NARWEE PARKLANDS CARE COMMUNITY

SSDA SUMMARY OF DESIGN CHANGES FOR DPE

Response to Submission Design Report for the Narwee Parklands Care Community

State Significant Development Application (SSD-45024776)

23rd of September- Developable Compliant Housing SEPP

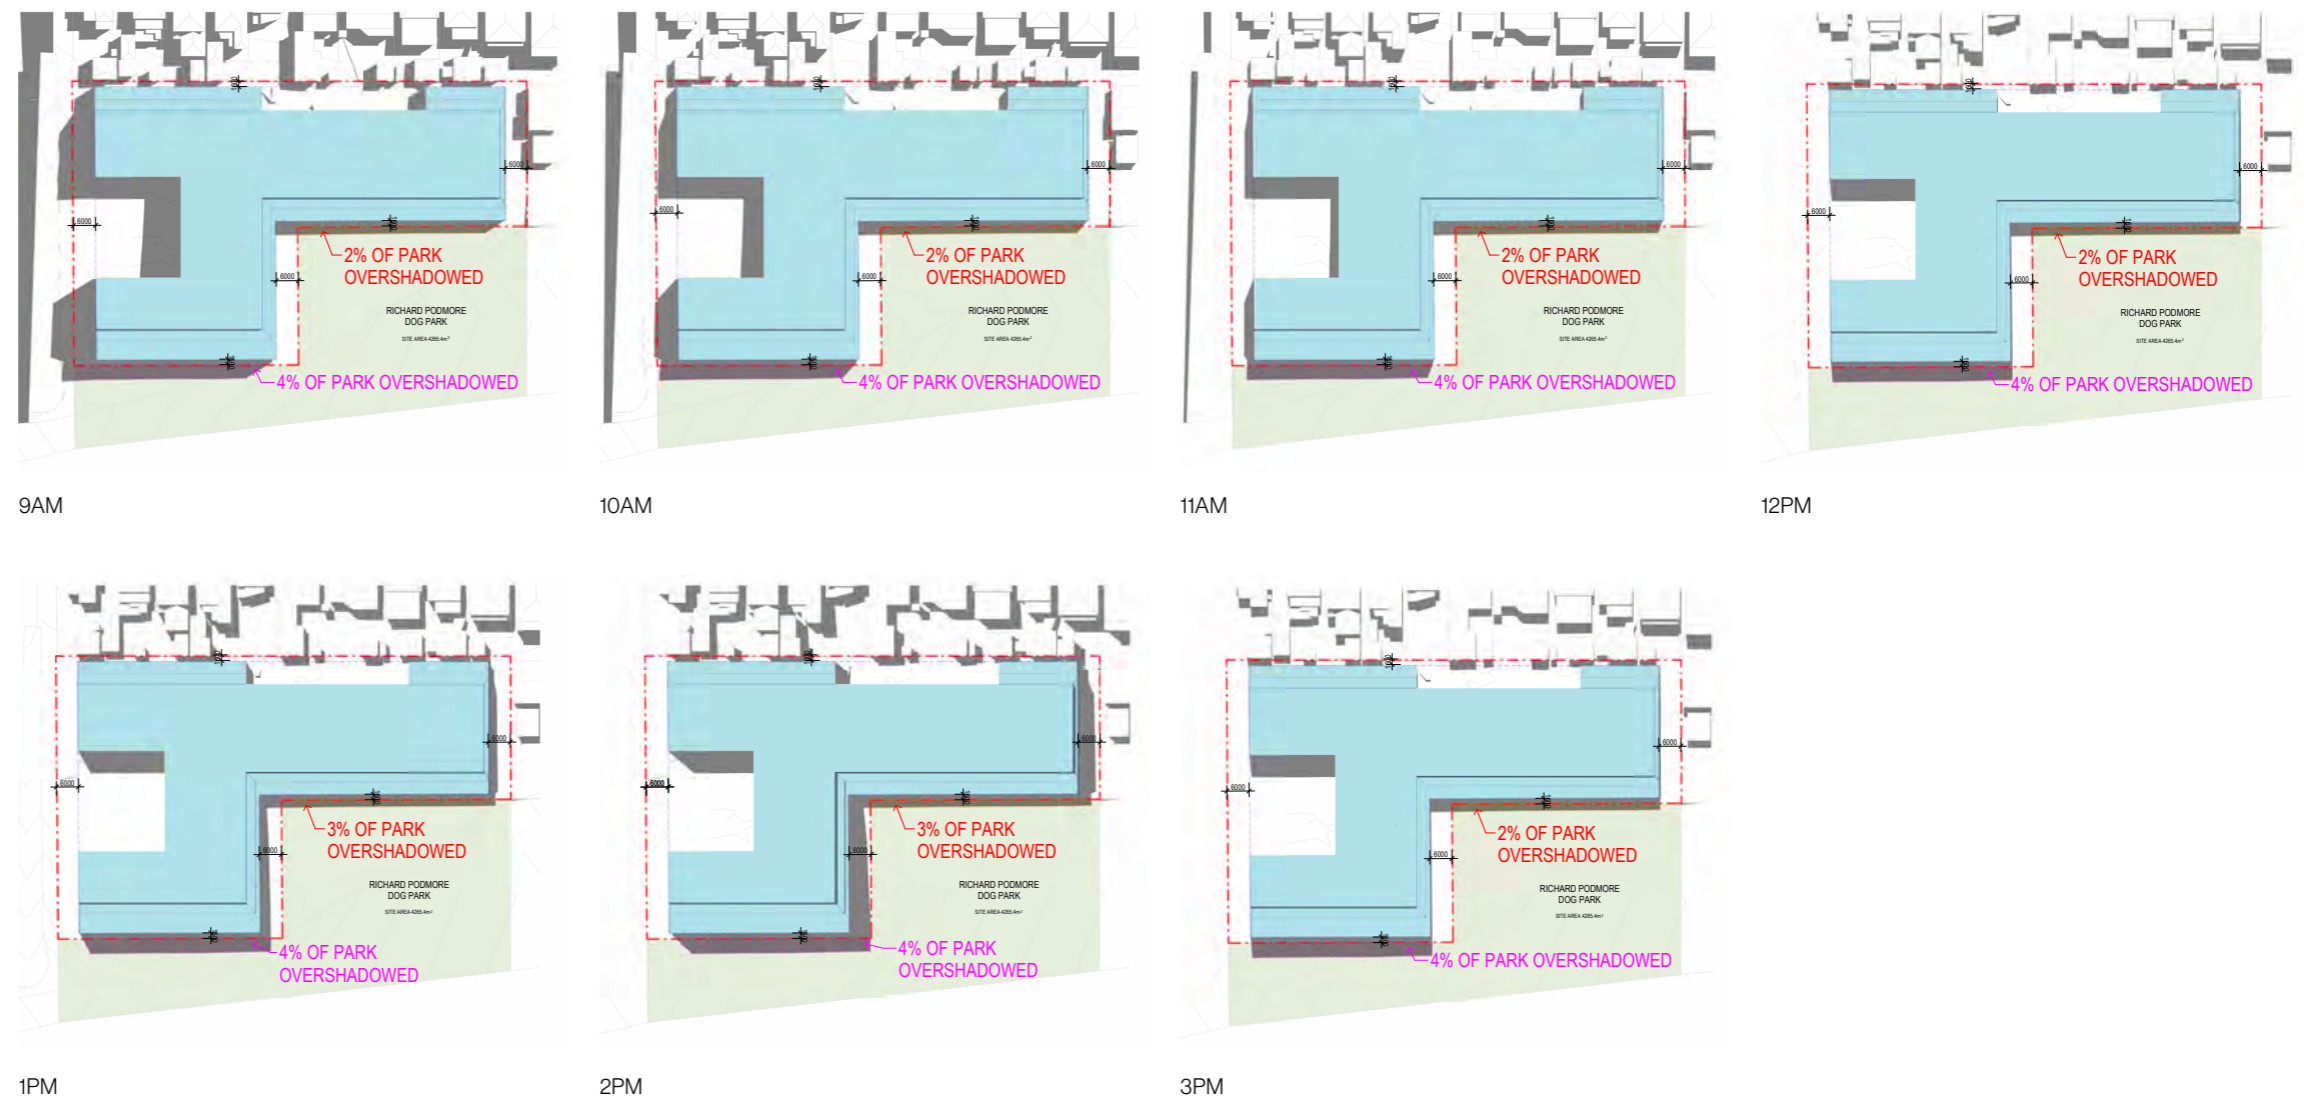
(d) Amended shadow diagrams are to be submitted that remove reference to the previous development on the site. The shadow diagrams must compare the impacts of the proposal against a complying built form.

The September Solstice Diagrams demonstrate the Developable Compliant Housing SEPP overshadowing for comparison.

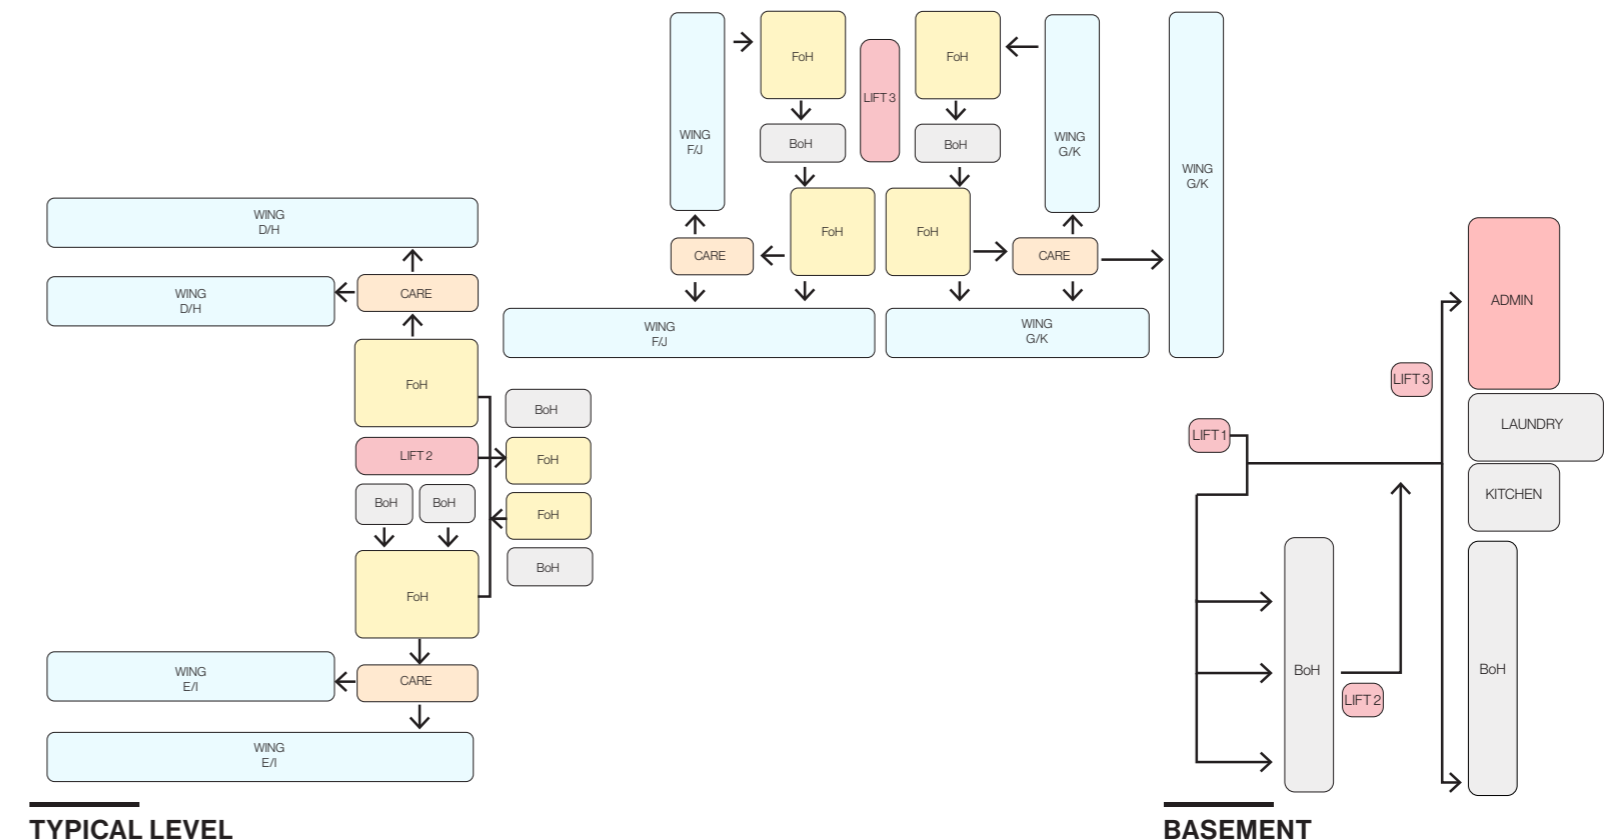
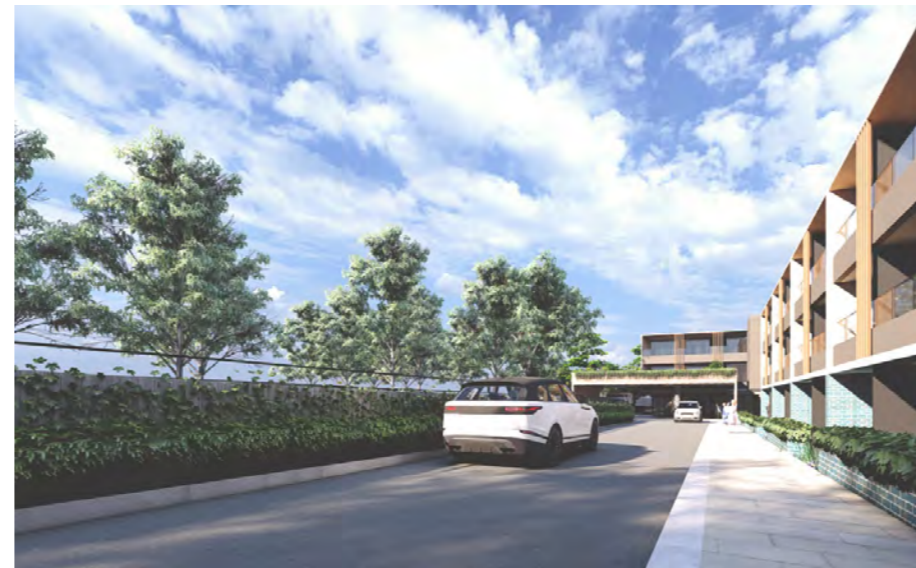
(c) The main site entry is dominated by driveways and ramps. Consideration is to be given to provide further landscaping in this area to provide an appropriate streetscape presentation and arrival experience.

(e) The fire access stairs leading from the basement to the ground floor are to be relocated so as

to not encroach upon the front setback area.

(c) Revised design has increased original 400mm wide planter boxes to 900mm wide planter boxes (with 600mm clear planting) along Ground Floor balconies. Native crawling plants have been proposed along the other side of driveways for screening to soften basement ramps concrete upstands and act as a visual green buffer.

(e) Western fire access stair leading from Basement to Ground Level has been relocated to avoid encroachment upon setback.

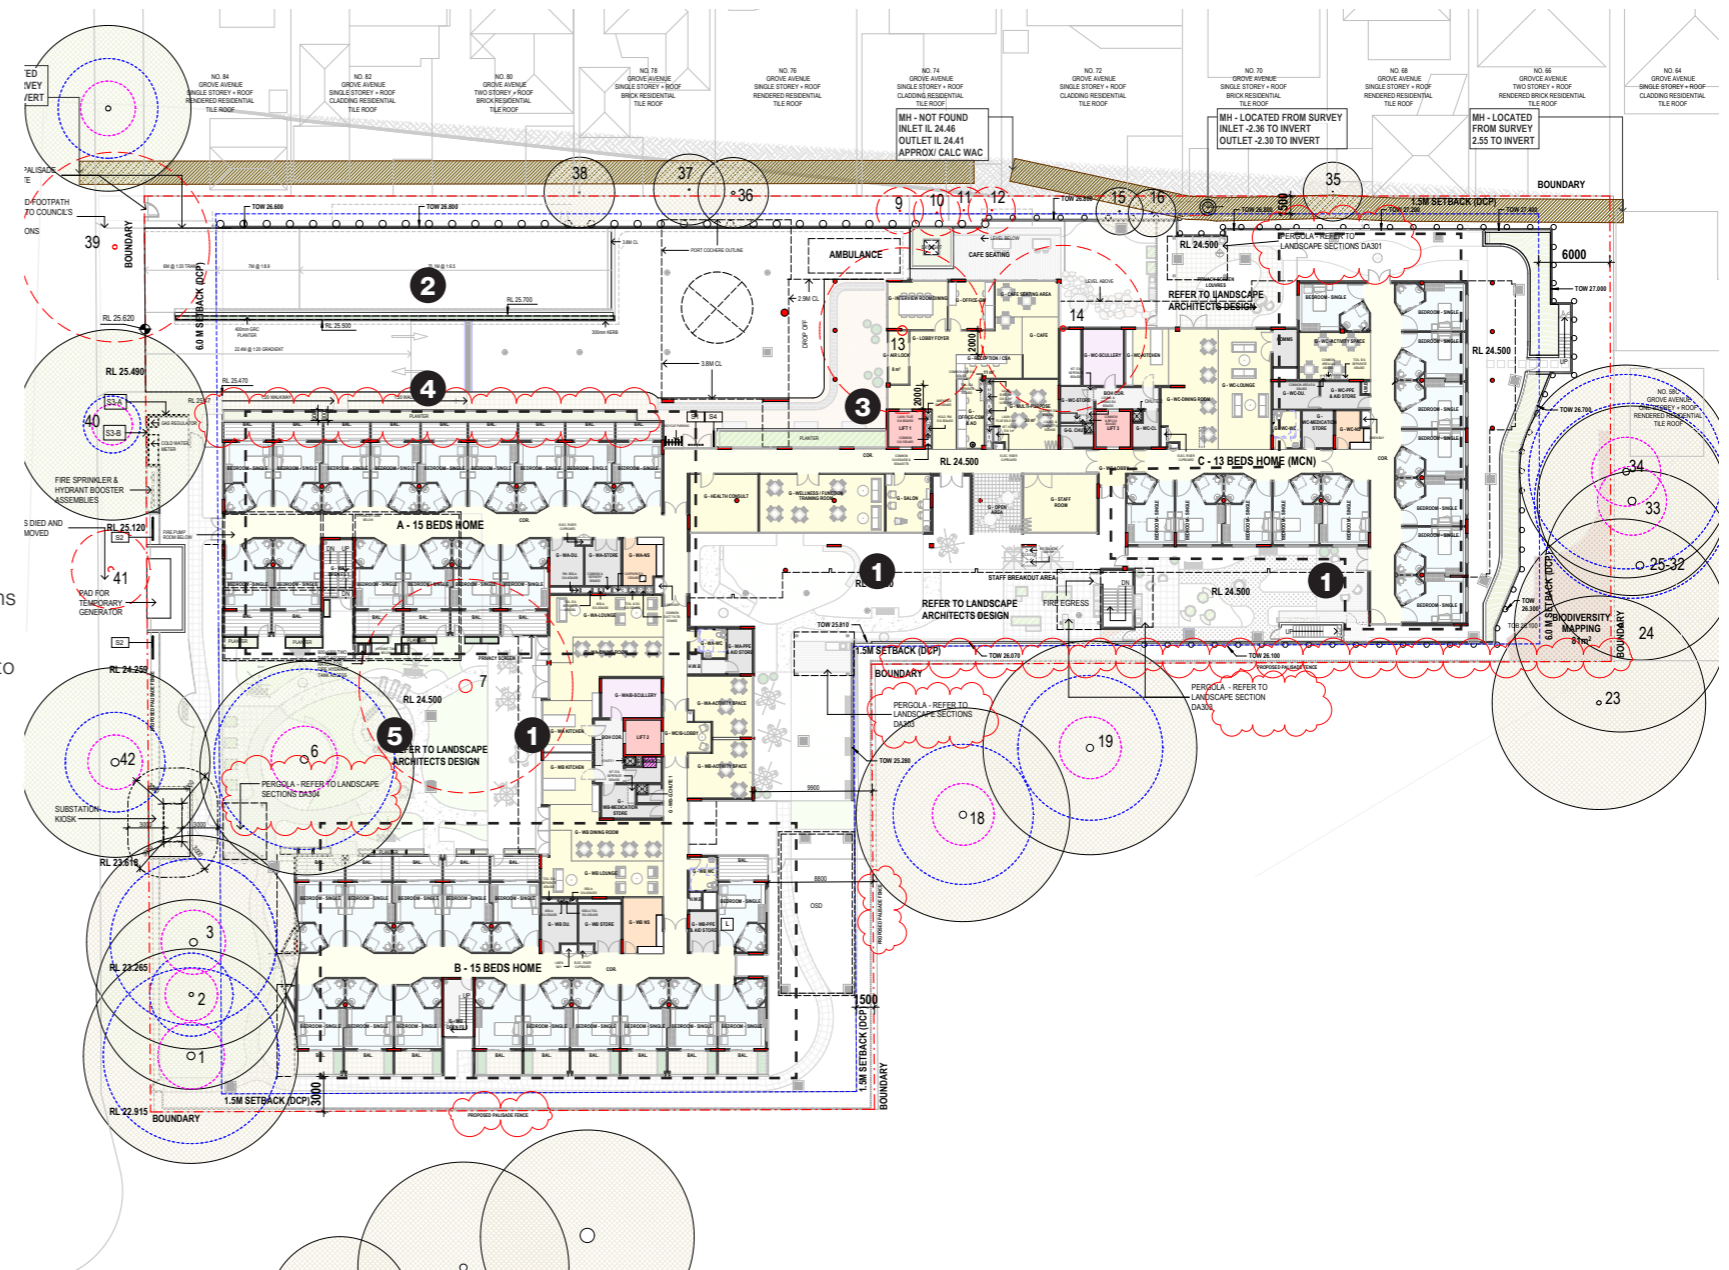
- **Architecture expression – Elevation and materiality** – the proposal should demonstrate compliance with the Seniors Housing Design Guide for "The Design for physical ageing and dementia". The proposal should also provide information on the proposed width of the common corridors used by the residents in accordance with the Australasian Health Facility Guidelines (Part C – Design for Access, Mobility, Safety and Security).

Designing for Physical Ageing and Dementia

- 1 Verandah
 - 2 Service Driveway to Common Service Core
 - 3 Front Entry Door
 - 4 Pedestrian Access to Front Door Entrances
 - 5 Central Courtyard with Glazing
- Single Household

EXTERNAL OPEN SPACE - SOLAR ACCESS
1:200

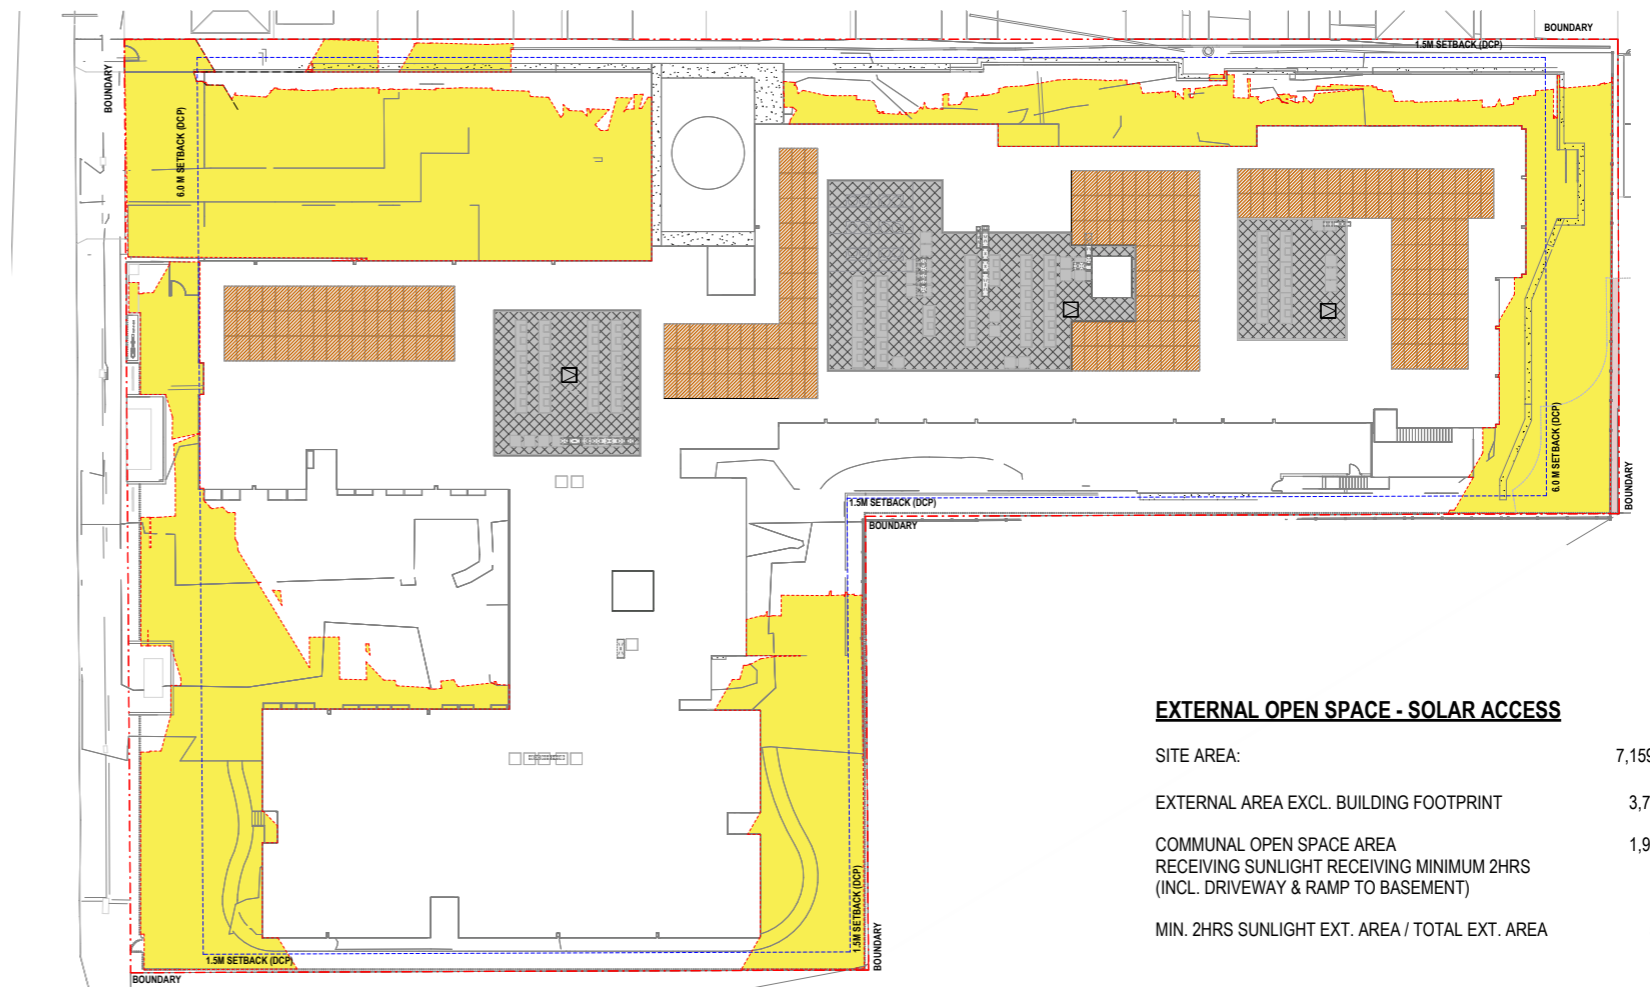
- Approximately 43% of units do not receive a minimum of 2 hours solar access during the winter solstice. Furthermore, shadow diagrams demonstrate the communal terraces for Wings A and B receive minimal solar access during winter. Therefore, the layout is to be amended to provide good solar orientation for an increased number of RCF units and communal terraces.

Adjacent diagrams demonstrate external outdoor open area which received more than 2 hours of sunlight during winter solstice.

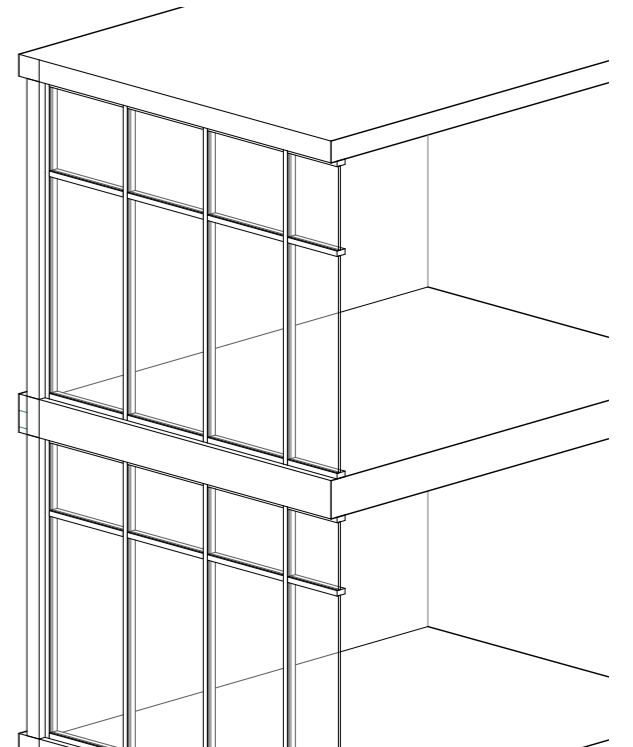
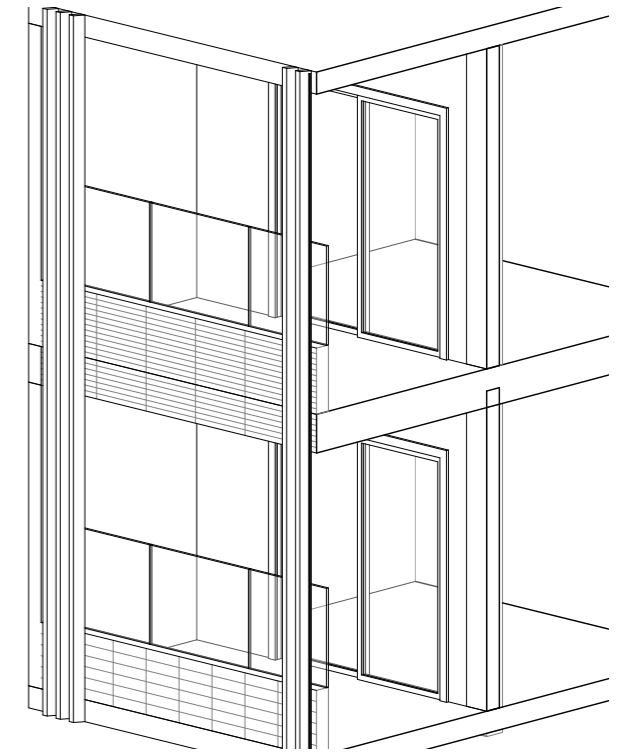
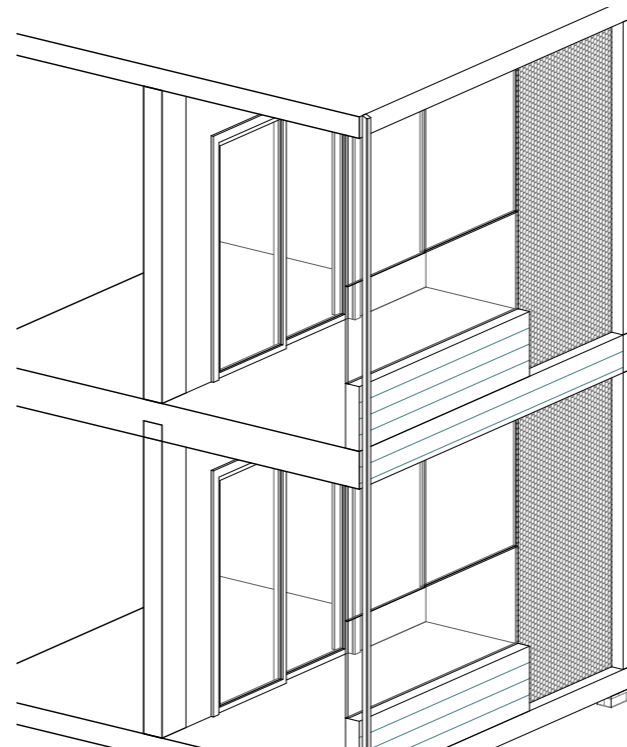
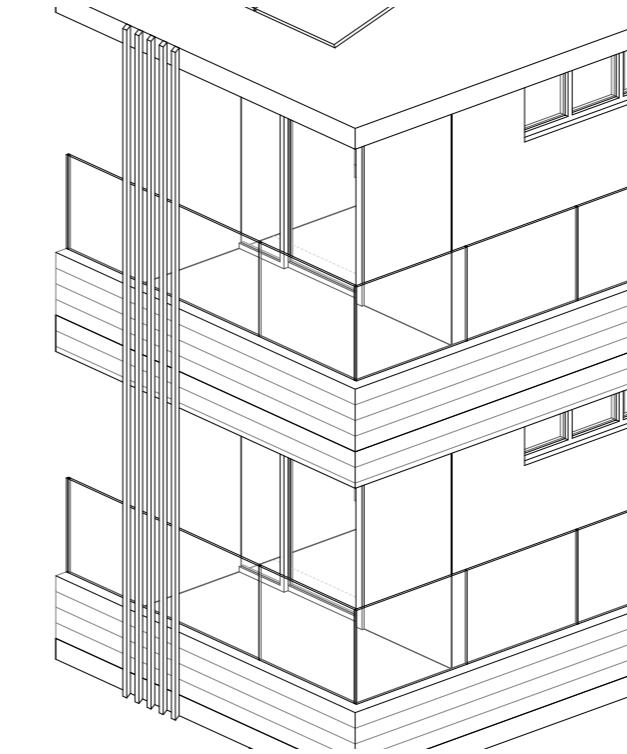
(a) The proposal results in adverse visual and acoustic privacy impacts as well as security concerns for the ground floor level units located adjoining the pedestrian pathway and driveway at the north-western corner of the site and is an unacceptable design outcome. Consideration should be given to increasing the width of the planter box along the path to provide increased residential amenity for these occupants as well as the provision of double glazing.

(b) The width of the proposed planter boxes at the ground floor level adjacent to the balconies of units facing the southern courtyard are to be increased to provide increased residential amenity for the occupants of these units.

(c) The proposal results in adverse visual privacy and acoustic impacts for residents where balconies of the units immediately adjoin communal terraces on levels 1 and 2 of the development as shown in Figure 1 below. This design and layout are to be revised to provide acceptable residential amenity for the occupants of these units.

(a) The proposed revised design has increased original 400mm wide planter boxes to 900mm wide planter boxes (with 600mm clear planting) along Ground Floor balconies. The widening of planter boxes improve privacy and enhance visual. Native crawling plants have been proposed along the other side of driveways for screening to soften basement ramps concrete upstands and act as a visual green buffer. From the above, the north-western design has been revisited and has improved outlook from Homes and building entry presentation; and improved continuity greenery, from street trees, to crawling plants along driveway upstands, and wider planter boxes along footpath.

(b) Planter boxes adjacent to Ground Level rooms facing the courtyard have been widened to enhance quality of amenities. The balconies and allied landscape edges will provide good visual separation and screening of residents from the driveways. The 'green' driveway and improved landscape along pedestrian entry sequence to residents' balconies has been significantly improved, with broader pavement to main entry.

(c) Design and layout have been revised to address privacy and acoustic concern for residents where balconies of the rooms immediately adjoin communal terraces on Level 1 and 2. Privacy screens and room swop have been proposed for better design outcome.
